Conway Planning Commission  
Staff Report

7:00pm • October 16, 2017 • 810 Parkway Avenue

**CONWAY CITY PLANNING DEPARTMENT REVIEW SALEM OAKS SUBDIVISION PRELIMINARY PLAT SUBMITTED BY WATSON & WATSON**

**SALEM OAKS SUBDIVISION**  
 CITY OF CONWAY  
 LOT PLAN

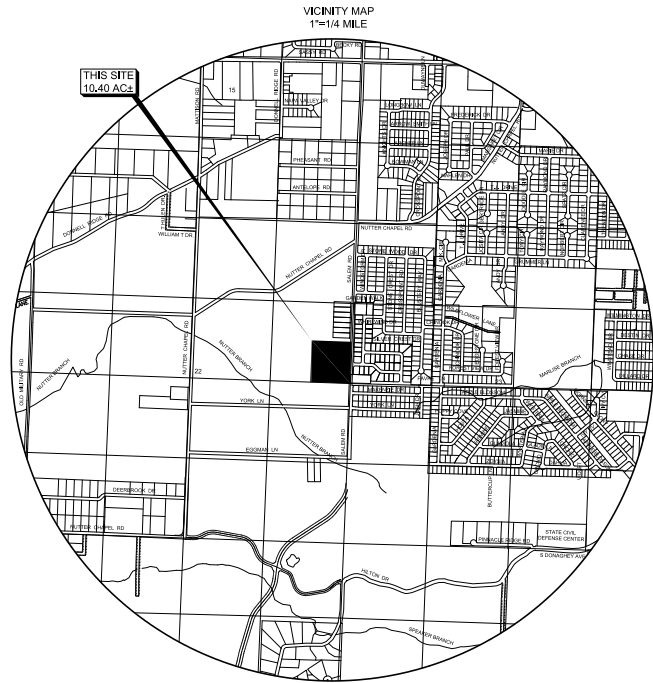
1. If any portion of the land being subdivided is subject to flooding, the limit of such flooding shall be noted and the appropriate 100 year floodplain and/or floodway shall be identified.
2. The present zoning classification, if any, of the land to be subdivided/replatted and of the adjoining land contiguous to the boundary of the proposed subdivision/replat is needed. Property is zoned A-1. Preliminary Plat approval is contingent upon land being rezoned to R-1.
3. The layout of all proposed sidewalk systems are needed, along with relevant dimensions and bearings.
4. A phasing plan outlining the boundaries for each phase and the location of all CAGIS monuments for the subdivision is needed. A minimum of two CAGIS monuments shall be placed in each subdivision or subdivision phase exceeding ten (10) acres.

12. State Fire Code 503.0.5 states that dead-end fire apparatus access roads in excess of 150 feet in length shall be provided with an approved area for turning around fire apparatus. Anything other than the following cul-de-sac requirement must be approved by the Conway Fire Marshall. Preliminary Plat approval contingent on fire marshal approval of fire apparatus turnaround on Shadow Lane.

16. Double frontage lots other than corner lots fronting on two streets shall not be platted except under extreme circumstances, as may be approved by the Planning Commission. ***Future extension of Favre Lane will create double frontage lots 13, 14 & 15. Planning Commission must approve these double frontage lots or this condition must be corrected.***

17. On double frontage lots, a planting screen easement of at least 10 feet shall be provided along the portion of the lot abutting a traffic artery or other use where screening is required. There shall be no right of access across the planting screen easement and such restriction shall be clearly designated on the plat and within any Bill of Assurance. Include Planting Easement for lots 12, 13, 14, 15 & 25 along the South boundary lines. Include a Planting Easement for lots 1 & 23 along the east boundary line.

Staff recommends the approval of the preliminary plat subject to the amended punch list.

**POSSIBLE MODIFICATIONS TO THE ORIGINAL PUD FINAL DEVELOPMENT PLAN**

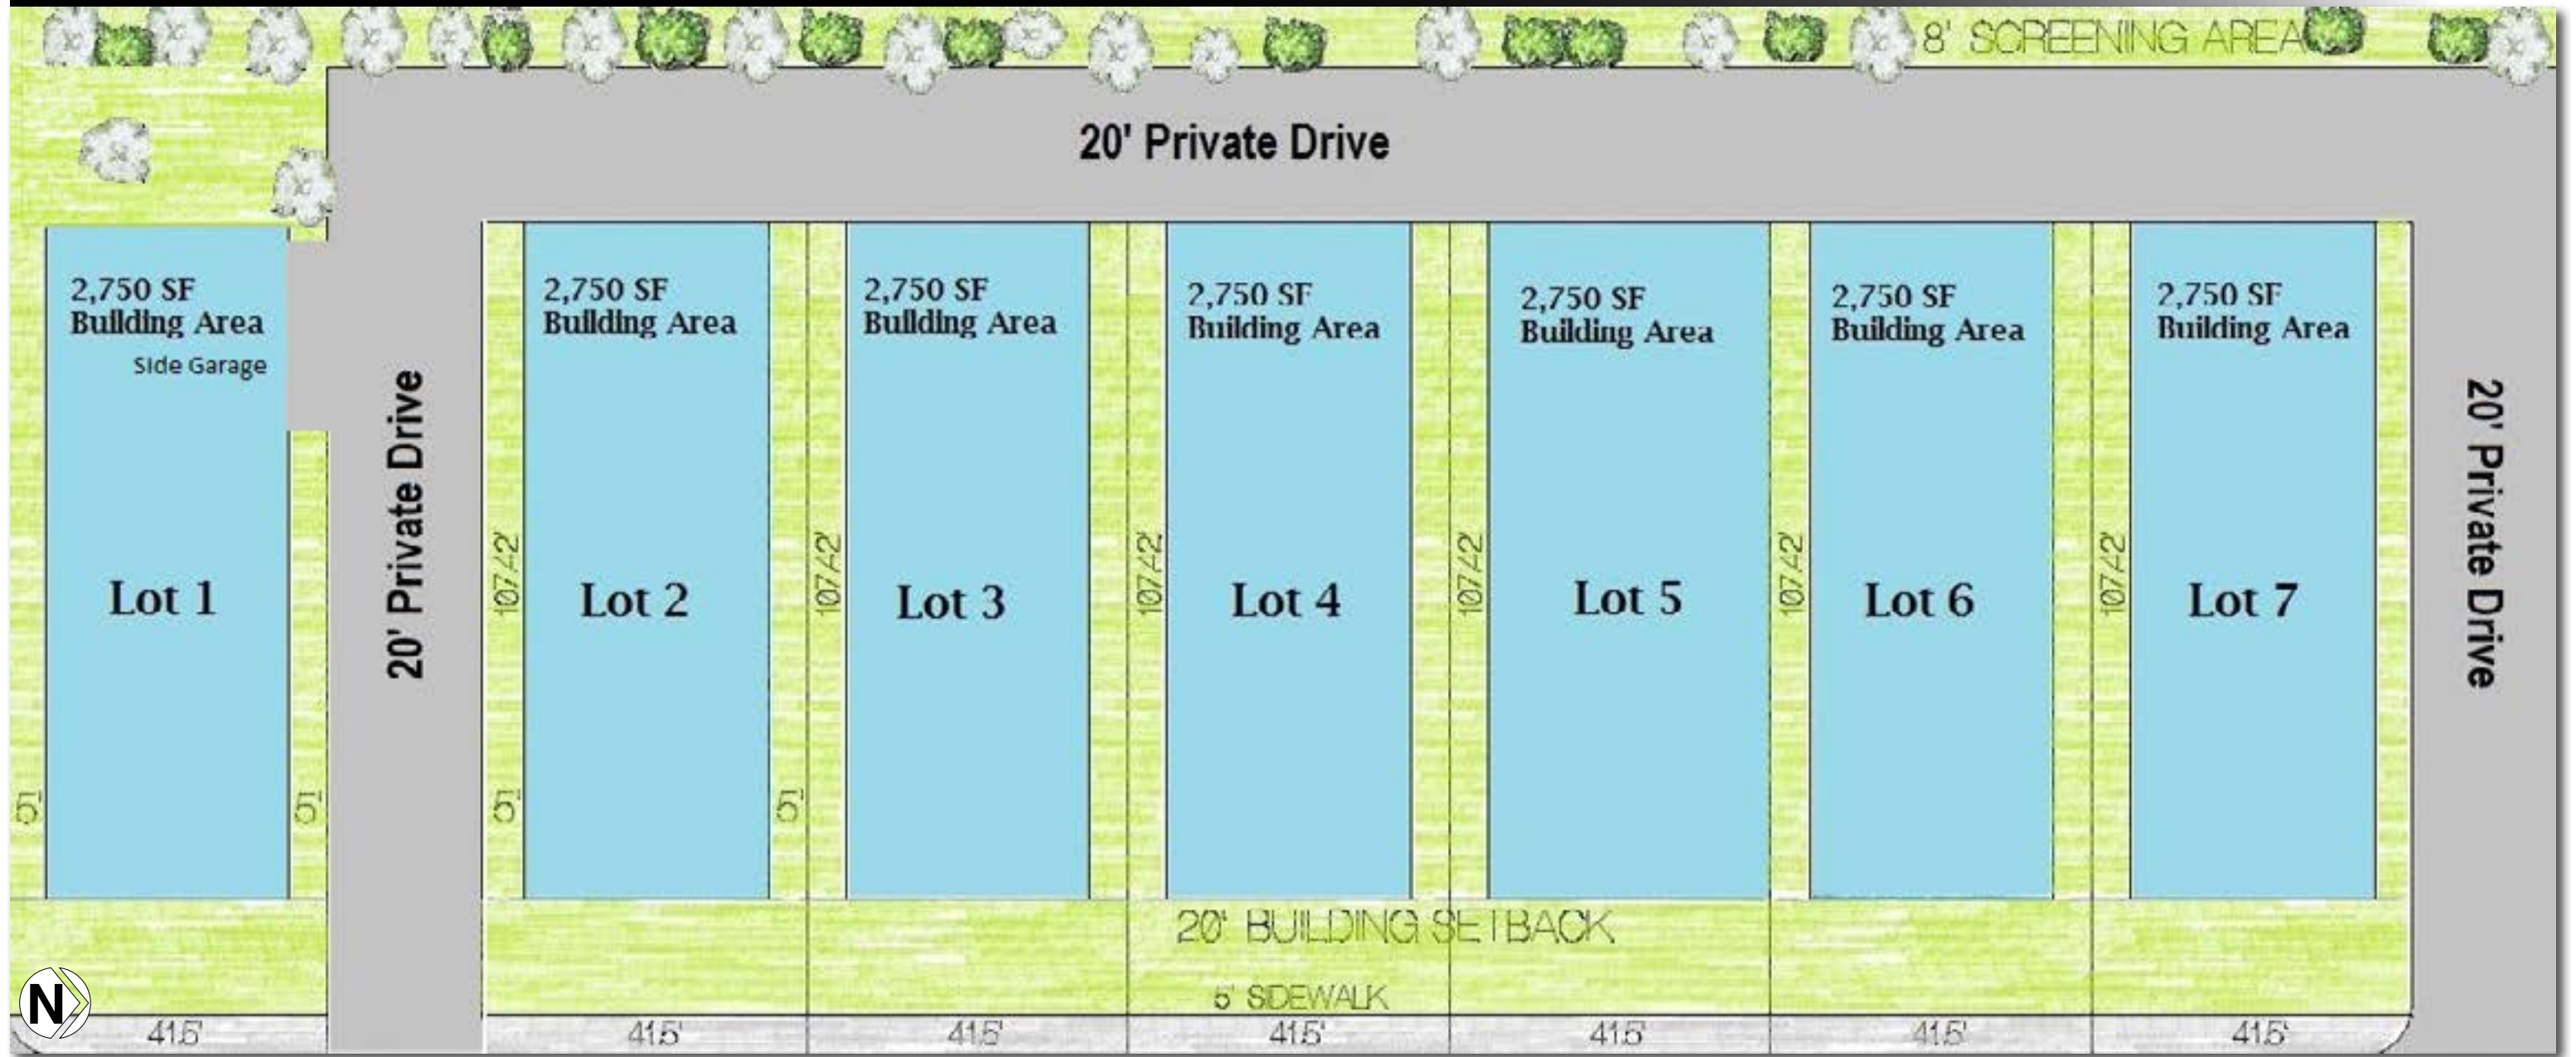
The applicant is seeking to reconfigure the existing 3 vacant lots into 7 smaller lots. There would be two curb cuts serving the proposed 7 residences. The curb cuts would provide access to a 20 foot rear alley. The residences would have rear-loading garages. There would also be an 8 foot landscape buffer at the rear (west) property line to allow for the planting of trees and screening vegetation. The original PUD plan also requires an 8 foot privacy fence to be built along the property lines. An 8 foot fence exists along the property line with the exception of the northern most lots, where there is an existing 6 foot privacy fence.

The applicant also seeks to amend the front setback from 25 feet to 20 feet. This was not addressed in the conditions of the PUD, but the approved plan and plat show a 25 ft front setback.

On October 3, 2017 a neighborhood input meeting was held at Conway City Hall. Three area residents attended the meeting. The neighbor's expressed concerns about possible light pollution from cars accessing the alleyway and requesting one way access with the ingress located on Lot 1 and exit at lot 7 (as shown on the proposed PUD amendment plan). There was also some discussion concerning second story windows overlooking the rear yards of existing Applewood Cove residences.

17. The text concerning Lots 1-4 Club Villas PUD as shown on Plan "Option 4" approved on February 15, 2011 shall be superseded with conditions 18-22.
18. Lots 1-3 Club Villas PUD shall be allowed to replat into 7 single family residential lots as shown on the plan as reviewed by the Planning Commission on October 16, 2017. Single family residential shall be the sole allowed land use.

19. PUD shall be generally developed as shown on the October 16, 2017 site plan. Minor variations from the submitted plan shall be allowed for technical reasons. However, the density and intent of the site plan shall be followed.

20. The submitted conceptual front elevations as reviewed by the Planning Commission on October 16, 2017 shall be used as general guides for the overall style of the residences.
